Explanation of Significant Difference
From the
Final Record of Decision for the
Naval Reactors Facility - Operable Unit 8-08
Idaho National Engineering and Environmental Laboratory

Signature sheet for the Explanation of Significant Difference to the Record of Decision for Operable Unit 8-08, located in Waste Area Group 8, Naval Reactors Facility at the Idaho National Engineering and Environmental Laboratory, between the U.S. Department of Energy and the Environmental Protection Agency, with concurrence by the Idaho Department of Environmental Quality.

Figure 2 The Relation of Original Basin to the Expanded Basin

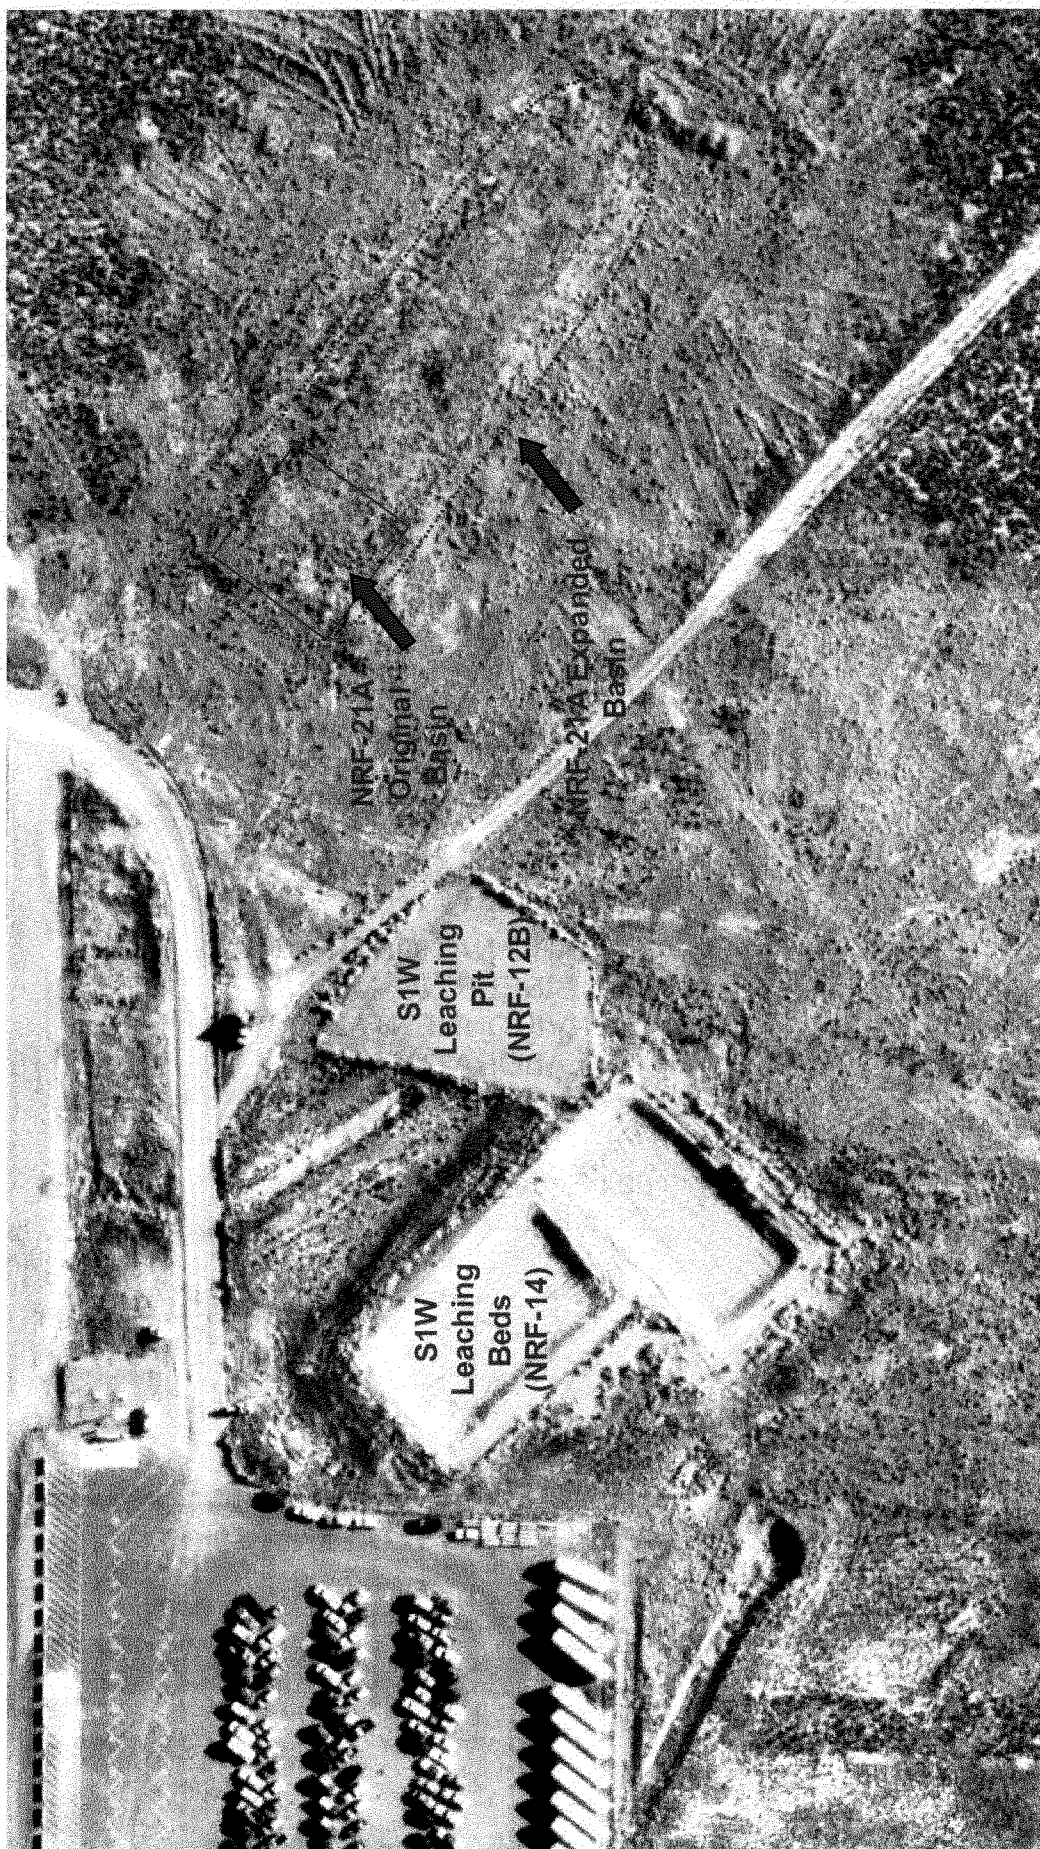
NRF-21A, the Old Sewage Basin, was constructed in 1956 and was enlarged in 1957. It is located outside and southeast of the security fence. Figure 2 shows the relationship between the original basin and the expanded basin. NRF-21A was operated as an open pond until 1960 and was subsequently filled in and abandoned. In 1956, the basin was cross-contaminated from the radiological discharge system. During an investigation of the site in 1991, and again in 1996 during the Remedial Investigation, samples were collected from the basin area. Results from the investigations indicated the presence of nine contaminants of potential concern (COPCs). The list of COPCs included antimony, arsenic, cadmium, chromium, mercury, silver, N-nitrosodi-n-propylamine, cobalt-60, and cesium-137. Only Cesium-137 was detected at concentrations that would pose an unacceptable risk via direct exposure to potential receptors at this site. On the basis of sampling results, the RI/FS concluded that the extent of contamination requiring remediation was limited to a two-foot thick layer located near the discharge pipe at the bottom of the original basin. The RI/FS estimated the volume of contaminated soil for this site at 10,400 cubic feet, based on a 72 X 72 square foot area with a two-foot thickness.

Remedial Action excavations conducted at site NRF-21A in 2000 and 2001 revealed that contamination at this site is significantly more extensive than originally estimated based on the RI sampling. The RI/FS estimated the volume of contaminated soil for this site at 10,400 cubic feet. Approximately 23,300 cubic feet of contaminated soil was removed from NRF-21A during the 2000-01 field seasons. Exploratory test trenches excavated in 2001 indicate that the site length is approximately 4.7 times the ROD estimate. The ROD estimated the original contaminated basin length to be 72 feet, but the new information revises this estimate to 340 feet. The revised estimate of contaminated soils that would require excavation under the existing remedy is 93,800 cubic feet, which is approximately nine times the estimate in the finalized RD/RA-I Work Plan.

Removal of the NRF-21A buried piping to the basin area, with its associated contaminated soil, will proceed as described in the Final ROD. Instead of removing the contaminated soil at the basin, the present excavation will be secured and filled. The 3 foot mounded area presently over the basin will be removed, and an engineered cover will be designed and constructed over the basin. The area to be covered is approximately 340 feet by 80 feet as shown in Figure 3. An initial assessment shows that a minimal soil cap can cover the majority of the area since contamination is not present until the 8 foot depth in the elongated portion of the basin. Contamination above cleanup levels, as close as 4 feet from the surface, has been detected in the original part of the basin and a slightly thicker cover may be required in this area. It is estimated that a 2 ½ to 3 foot thick cover (above natural grade) over the entire basin will be constructed. The design phase of the cover will consider factors such as subsidence, erosion, runoff, infiltration, and biotic intrusion, and will be documented in the Phase II RD/RA Work Plan. The modified remedial action option (an engineered cover) can be planned and constructed in conjunction with the cover planned at the S1W Leaching Beds (see Figure 3 above). Construction can proceed at both locations simultaneously.
